REVISION TRANSMITTAL

This sheet transmits Revision 3 to MTL-53-04, which:

MANDATORY**MTL-53-04****TITLE**

FUSELAGE - FORWARD FUSELAGE FASTENER INSPECTION

Figure 1. Rivet Inspection Area (Sheet 1)

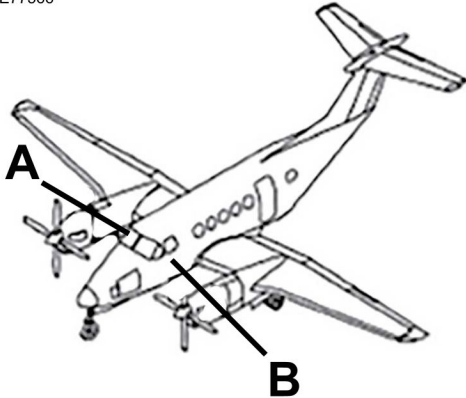
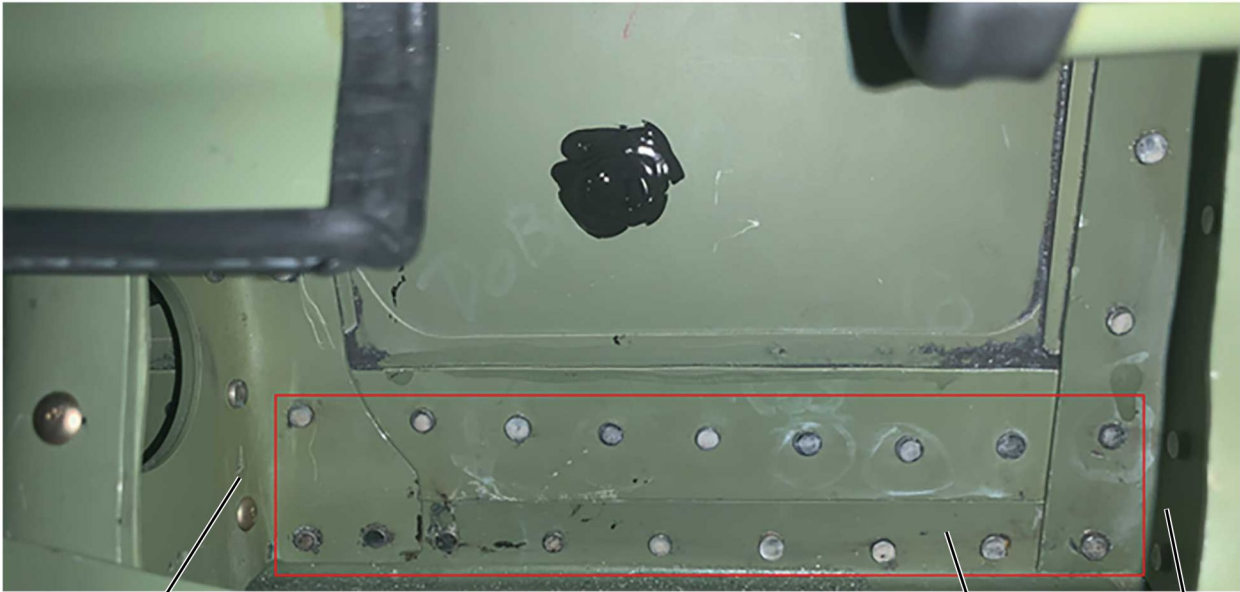
2. (Refer to Figure 1, Sheet 1.) Count the number of rivets installed between FS 100.50 and FS 107.00 on the left and right sides as follows:
 - NOTE:** FS 100.50 to FS 107.00 and Stringer 11 is located at the forward fuselage below the windscreen approximately halfway down the fuselage. The seam lines for the fuselage skin panels can be used for locating the location of FS 107.00 while FS 100.50 will be the next forward vertical row of rivets. (Refer to the applicable Model Maintenance Manual, Chapter 6, Dimensions and Areas, Airplane Stations - Description and Operations.)

NOTE: The rivets inside the red box show the area where the rivets need to be counted on the left and right sides of the fuselage.

Figure 1. Rivet Inspection Area (Sheet 2)

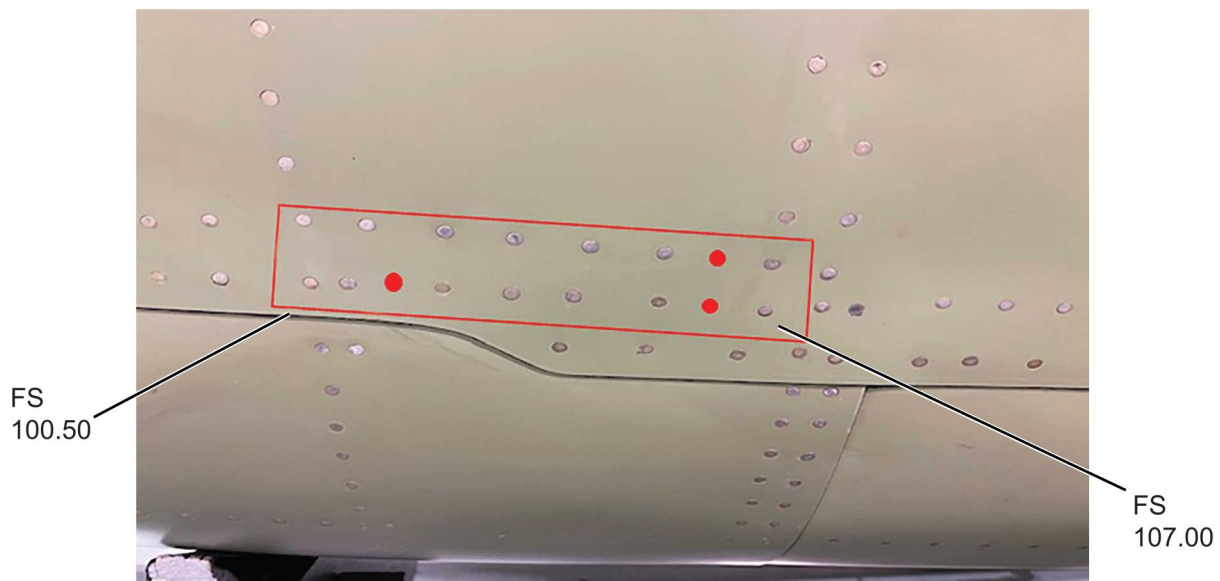
5. (Refer to Figure 1, Sheet 2.) Install the CM3827AD4-4 Rivets into the marked areas on the left side of all B200 and B300 models as follows:

11. (Refer to Figure 1, Sheet 2.) Install the CM3827AD4-4 Rivets into the marked areas on the right side of all B200 and B300 models without a FOD shield as follows:

NOTE: The rivets and red circle marks inside the red box show a possible configuration that would have a total amount of 16 or more rivets and marks.

- A. From the inboard side of the lap joint, drill a Number 30 (0.1285 inch diameter) hole as required for each of the marked locations on the left side.
- B. Debur all drilled holes.
- C. From the outboard side, counter sink all drilled holes to 100 degrees x 0.222 to 0.228 inch diameter.
- D. Apply Color Chemical Film Treatment to all bare metal.
- E. Install a CM3827AD4-4 Rivet, as required, wet with U470637 Sealant into all drilled holes. (Refer to the Beechcraft Structural Inspection and Repair Manual, Chapter 20, Fastener Installation and Removal.)
- F. If the rivet installation is needed on the right side, go to the steps that follow:
 - (1) If the rivets needs to be installed on the right side, go to Step 8.
 - (2) If only the left side needed rivets to be installed, go to Step 13.

- E. Install a CM3827AD4-4 Rivet, as required, wet with U470637 Sealant into all drilled holes. (Refer to the Beechcraft Structural Inspection and Repair Manual, Chapter 20, Fastener Installation and Removal.)

Figure 1. Rivet Inspection Area (Sheet 3)

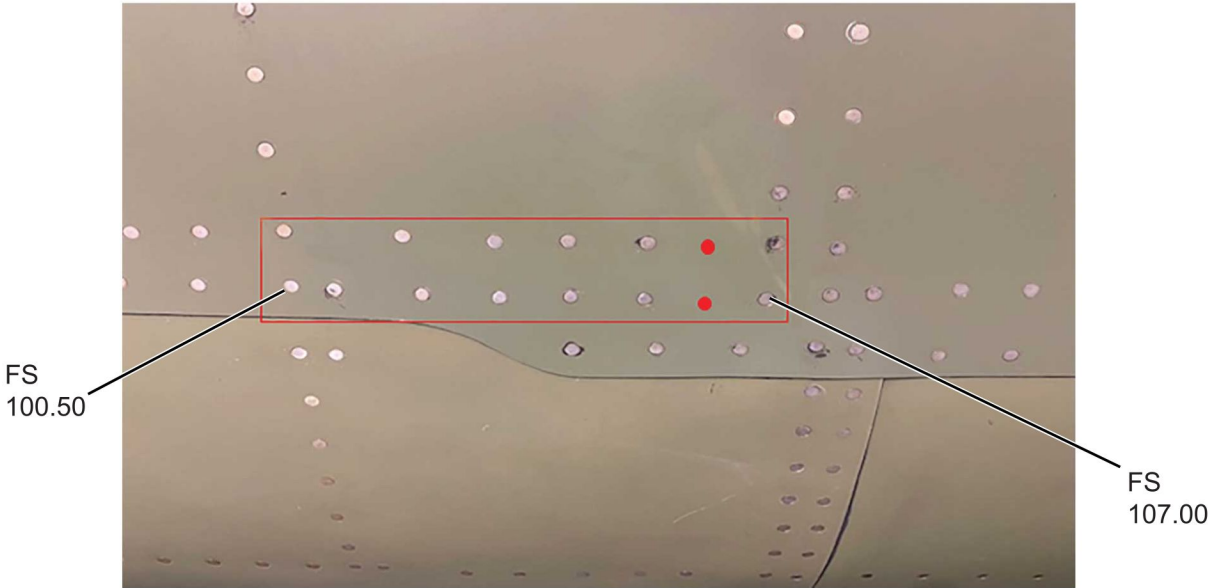
6. (Refer to Figure 1, Sheet 3.) Remove the previously installed rivets on the left side on all B200 and B300 airplanes as follows:

9. (Refer to Figure 1, Sheet 3.) Install a NAS1919B04S07, NAS1919B04S08, or NAS1919B04S09 Rivets on the right side of any B200 airplane with a FOD shield installed as follows:

12. (Refer to Figure 1, Sheet 3.) Remove the previously installed rivets on the right side on all B200 and B300 airplanes without a FOD shield as follows:

NOTE: The rivets and red circle marks inside the red box show a possible configuration that would have a total amount of 15 or less rivets and marks.

- F. Install a MS20427F4-4 Rivet, as required, wet with U470637 Sealant into all drilled holes. (Refer to the Beechcraft Structural Inspection and Repair Manual, Chapter 20, Fastener Installation and Removal.)

- D. Measure the required fastener grip length for each drilled hole and install from the outboard side a NAS1919B04S07, NAS1919B04S08, or NAS1919B04S09 Rivet, as required, wet with U470637 Sealant into all drilled holes. (Refer to the Beechcraft Structural Inspection and Repair Manual, Chapter 20, Fastener Installation and Removal.)

- F. Install a MS20427F4-4 Rivet, as required, wet with U470637 Sealant into all drilled holes. (Refer to the Beechcraft Structural Inspection and Repair Manual, Chapter 20, Fastener Installation and Removal.)

Figure 2. Rivet Installation Guide (Sheet 1)

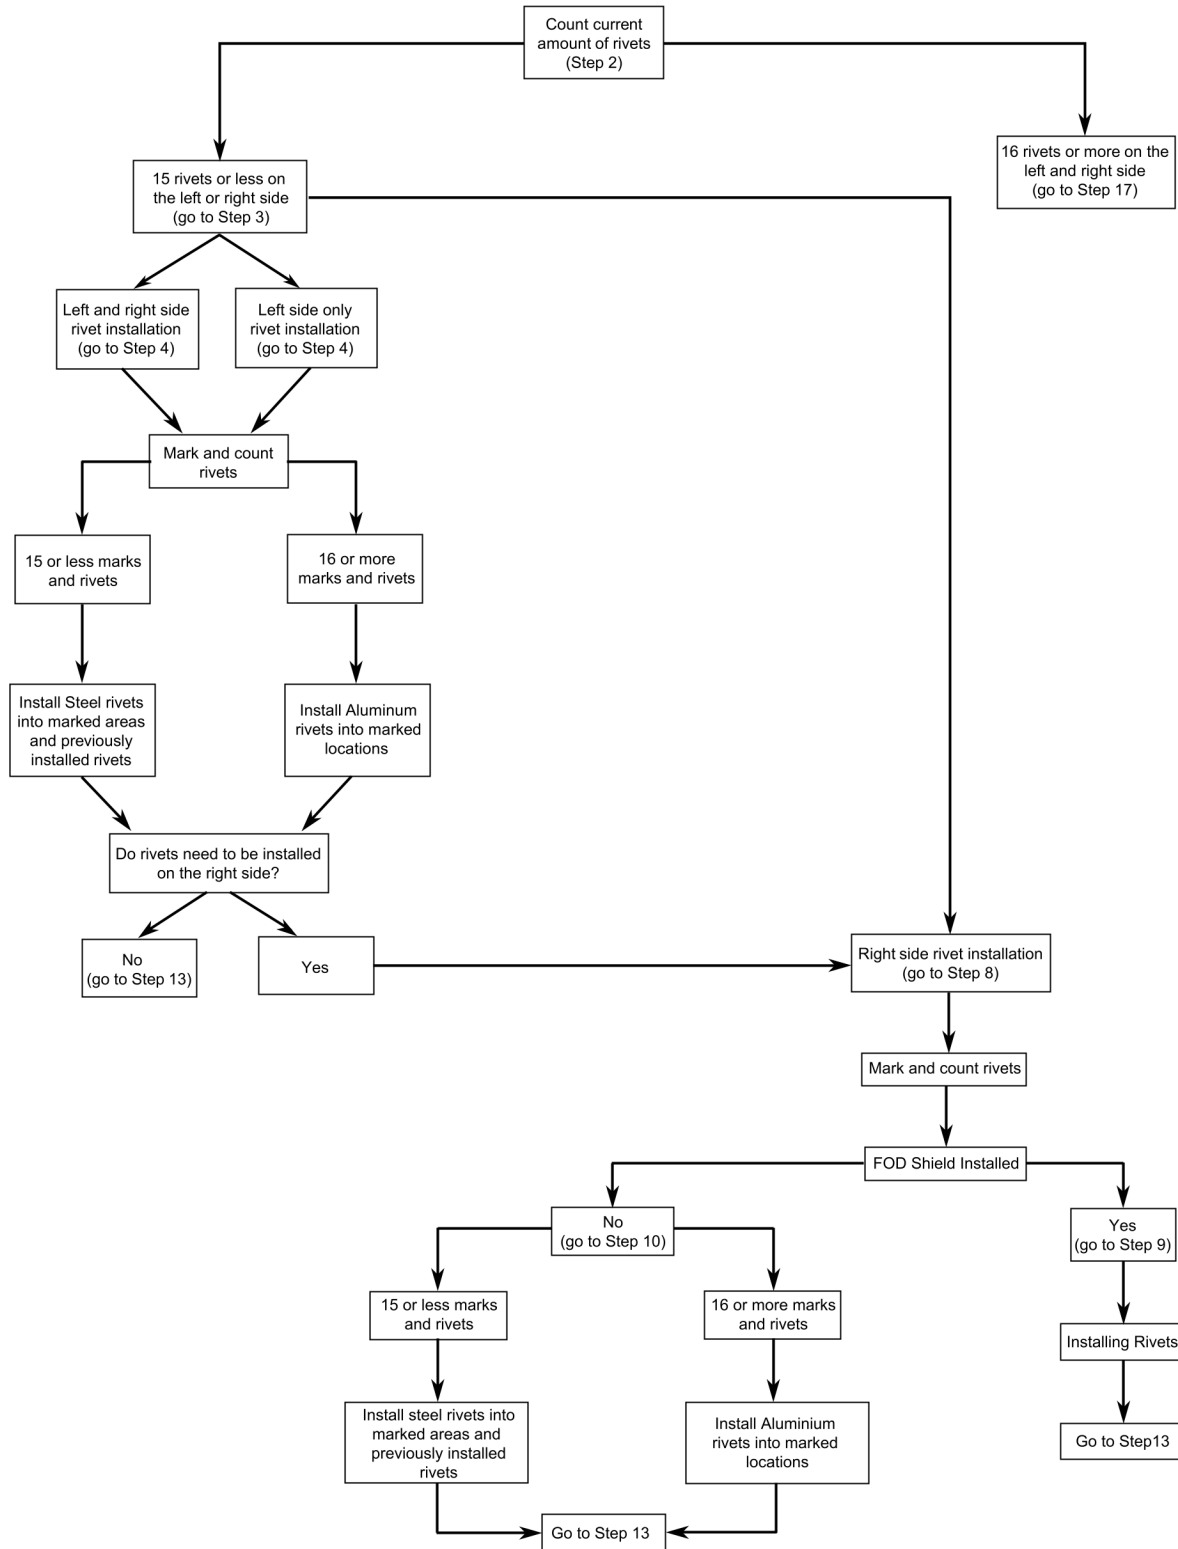
- A. (Refer to Figure 2, Sheet 1.) Thoroughly review the flowchart in Figure 2, Sheet 1.
 - NOTE:** The flow chart in Figure 2, Sheet 1 should be reviewed and understood prior to any counting, marking, or drilling. The flow chart can be used as a guide throughout the procedural instructions of this service document.
